### Proposed Revisions to a Standard Plans Index

Index Number: 550-012

Index Title: BRIDGE FENCING (ENCLOSED)

LAST REVISION 11/01/17	REVISION	DESCRIPTION:		FY 2023-24 STANDARD PLANS	BRIDGE FENCING (ENCLOSED)	INDEX 550-012	SHEET 1 of 4
---------------------------	----------	--------------	--	------------------------------	---------------------------	------------------	-----------------

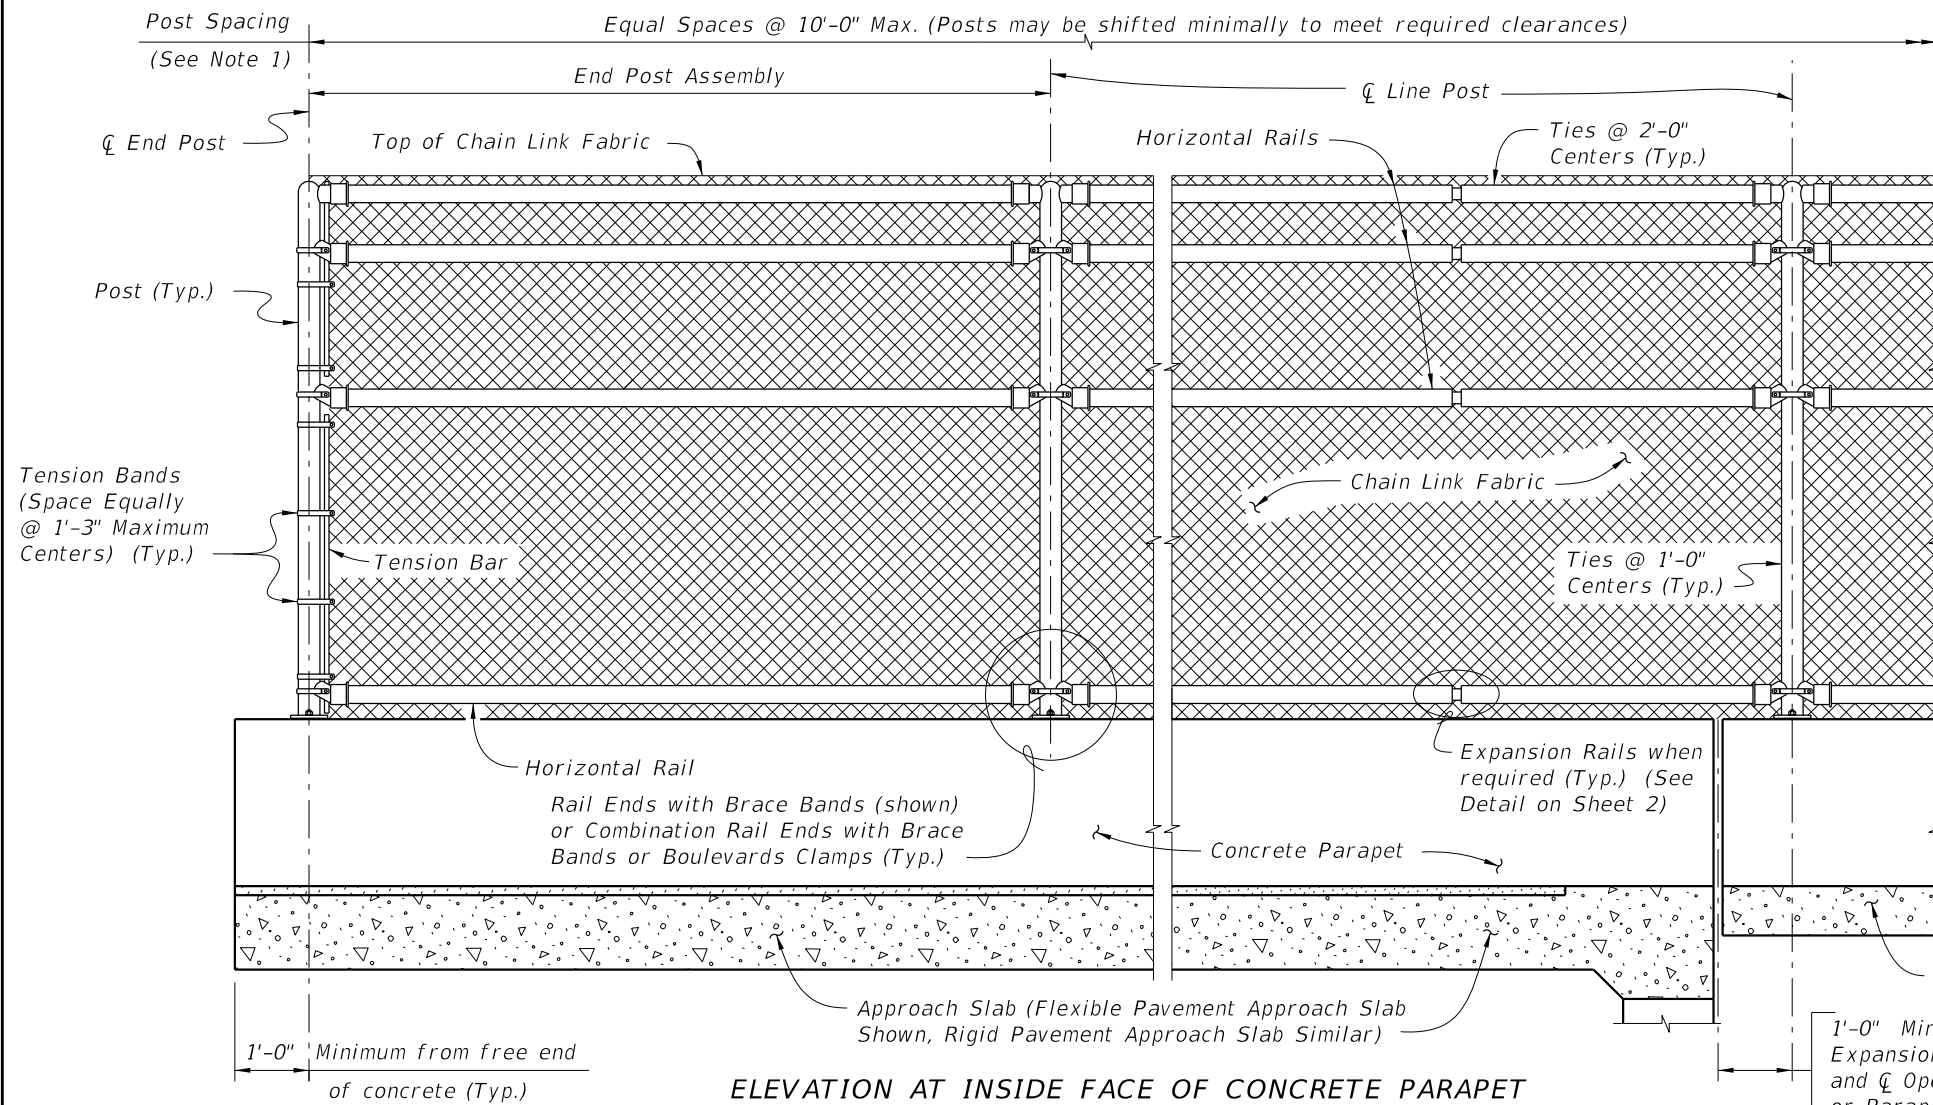
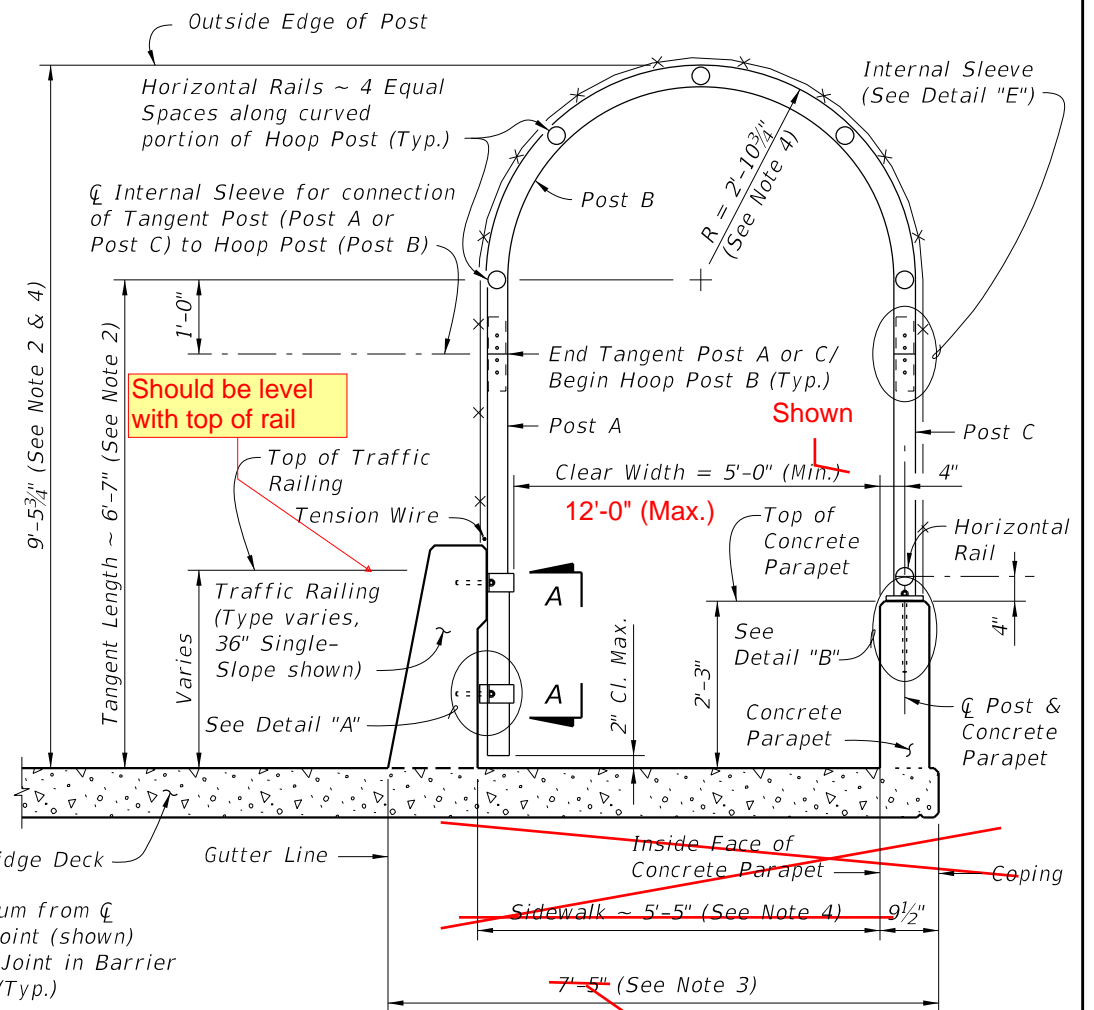
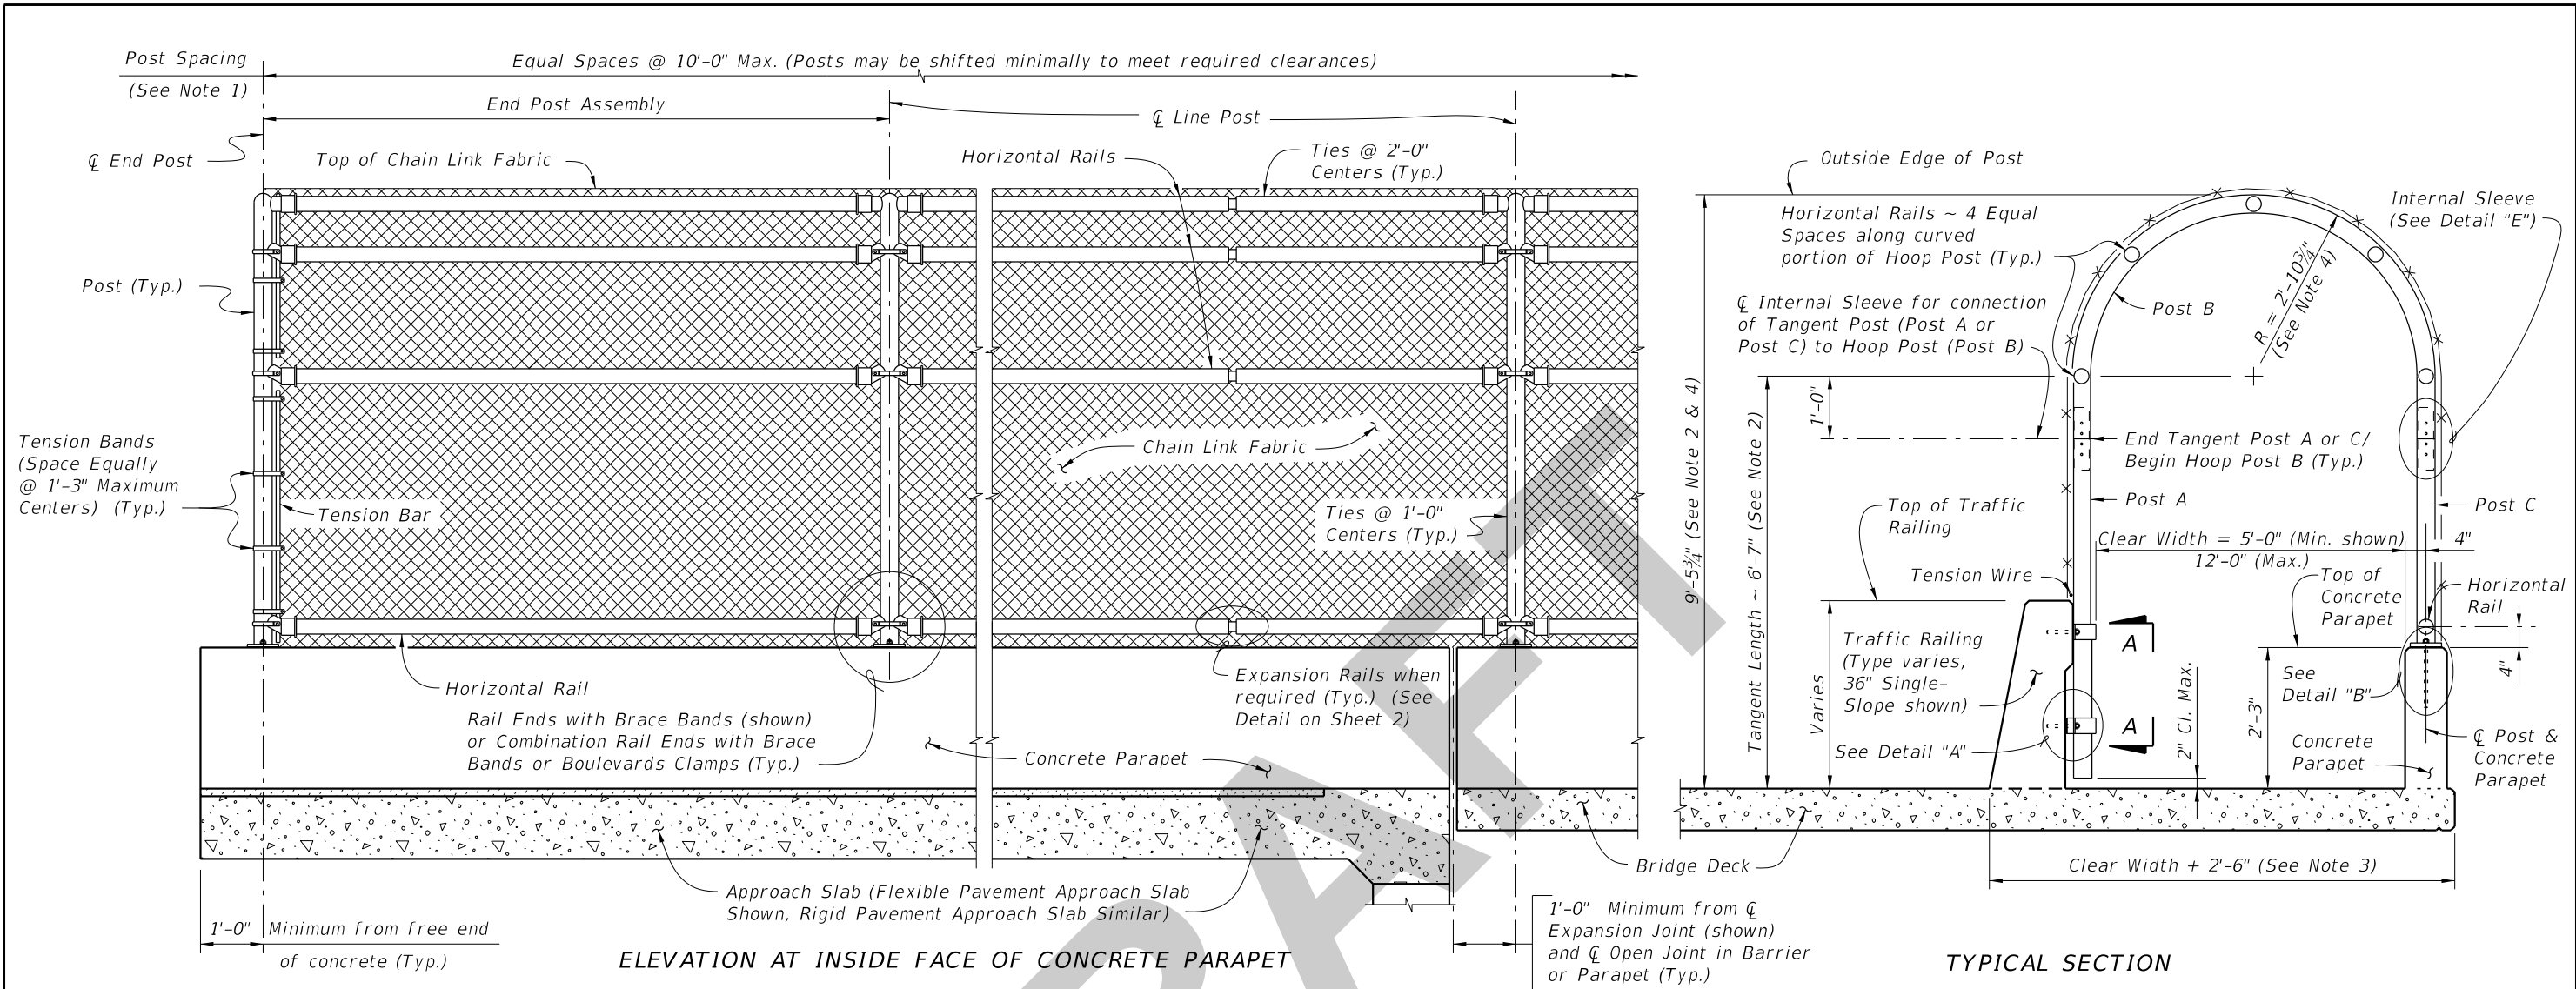
Sheet 1: Replaced the 7'-5" dimension because the calculated dimension is off by 3/8" and the dimension varies depending on clear width; Removed the 5'-5" dimension because it varies; Revised the Clear Width note from 5ft min to add 12 ft max.

An email came it that highlighted that the calculated dimensions do not match the Standard. It was determined that the dimensions were not required as they vary and recording them to the 1/8" would not be an ideal solution.

Standard allows for extension of the fencing for larger widths but those widths are not unlimited so we added a maximum of 12 ft.
